SPRC Meeting

SPLN22-00018 Inn of Rosslyn (1601 Fairfax Dr.)

New Site Plan and Rezoning (RZN25-00003)

RENDERING - SOUTHEAST (ARIAL)

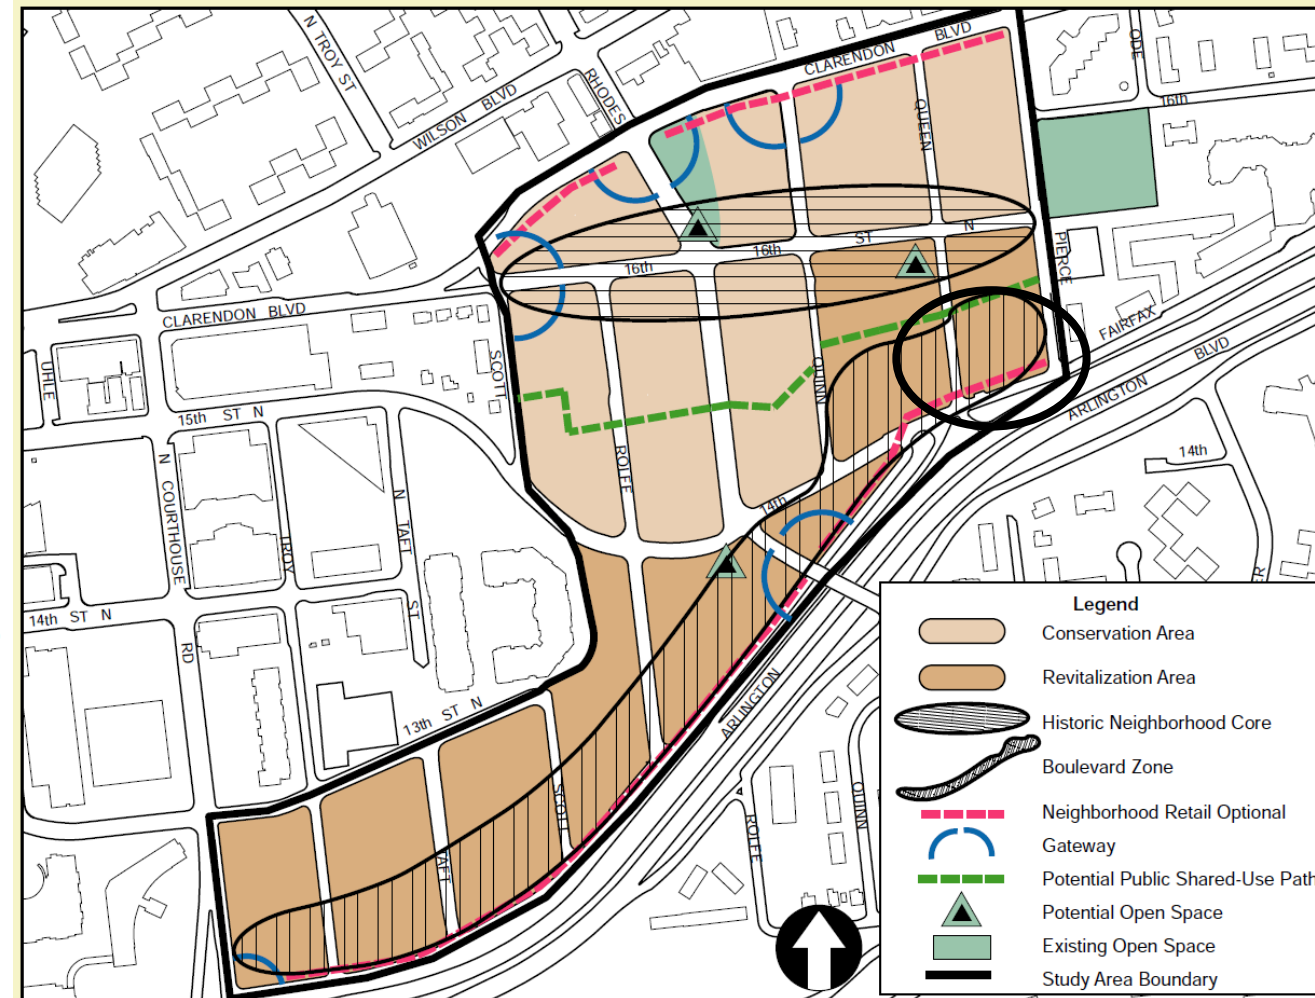
- 8 story residential
 - 142 units
 - 5.6 FAR
 - 85 parking spaces
 - Working with applicant to get proposed percentage of compact spaces down
- Stick over concrete construction

Site Design and Layout/Open Space

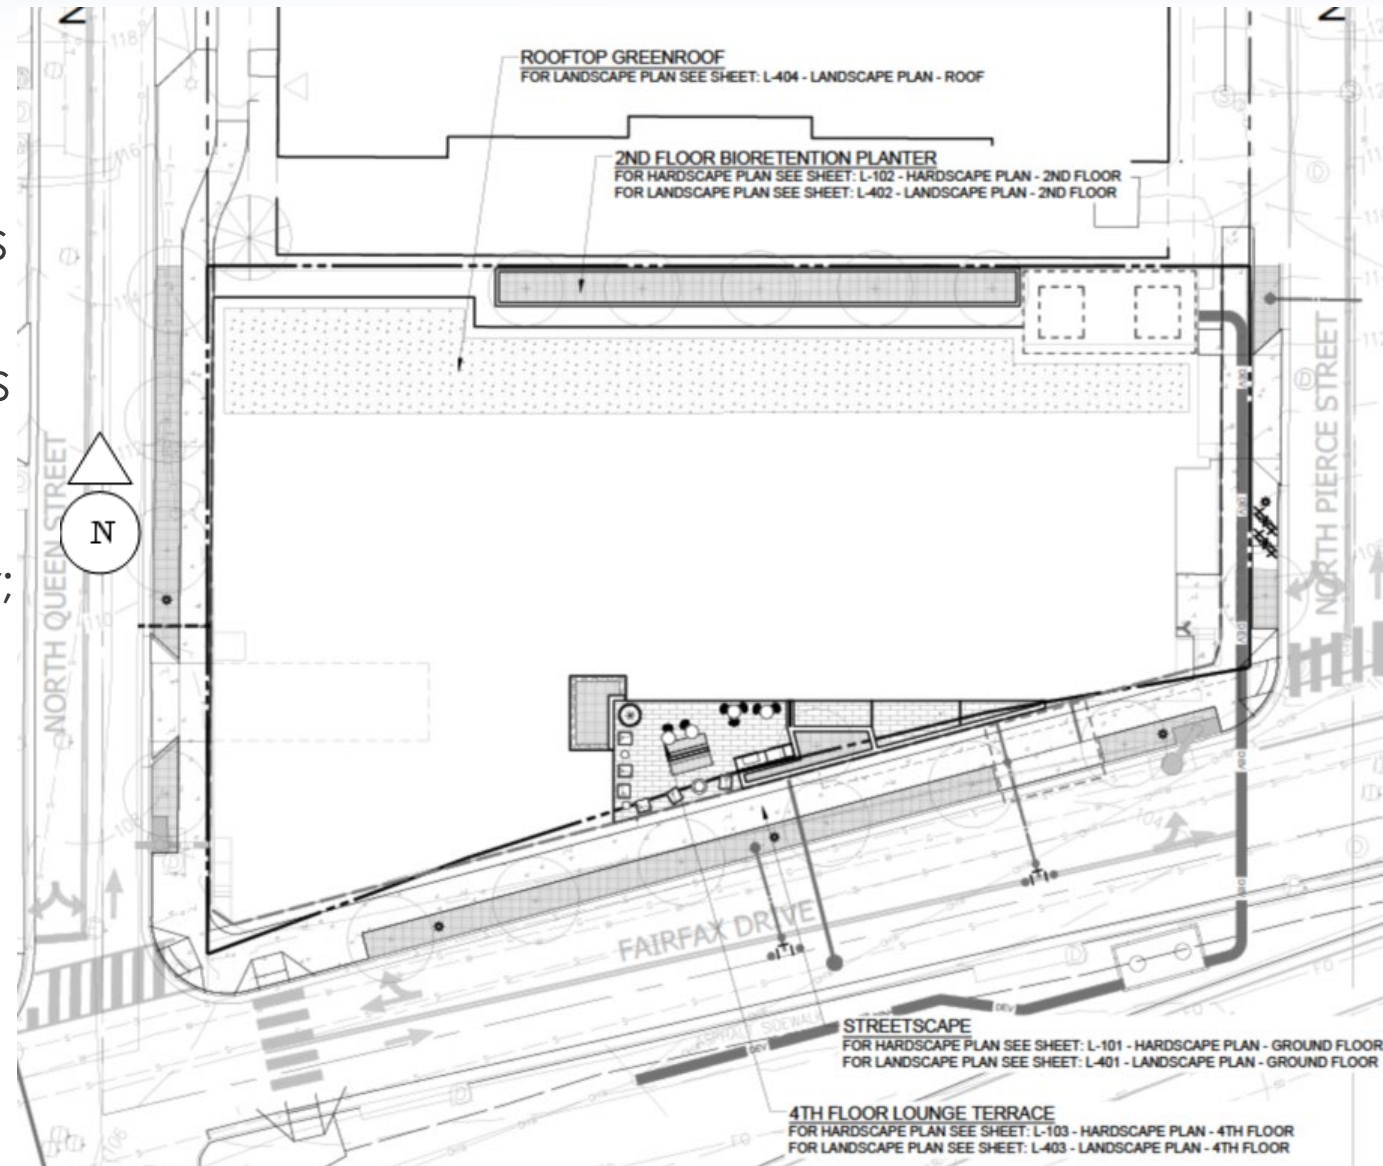
- Current site has no landscaping;
- Developer proposes green roof areas and street trees;
- Questions whether tree canopy goals and Ches Bay requirements can be met
 - Proposed trees in bioretention planter;
 - Street trees may be too close to building to create desired shade canopy.

Site Design and Layout/Open Space

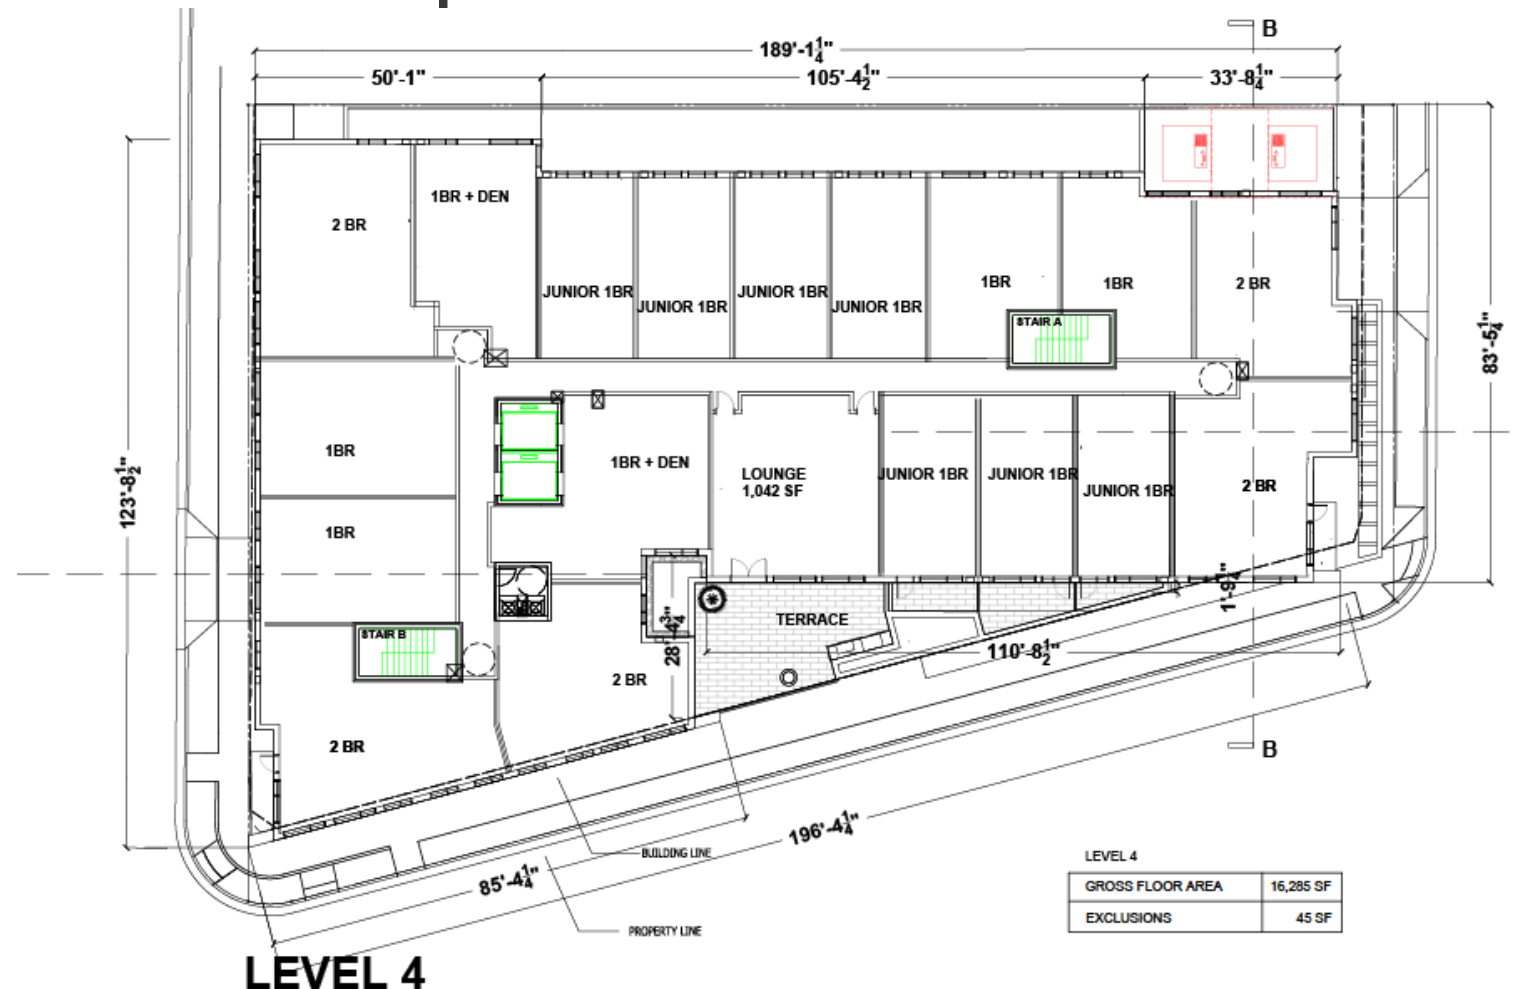
- Staff has been very consistent in stating to applicant that the lack of the open space is a serious deviation from the Area Plan
- Private open space does not have specific target size, location may be flexible
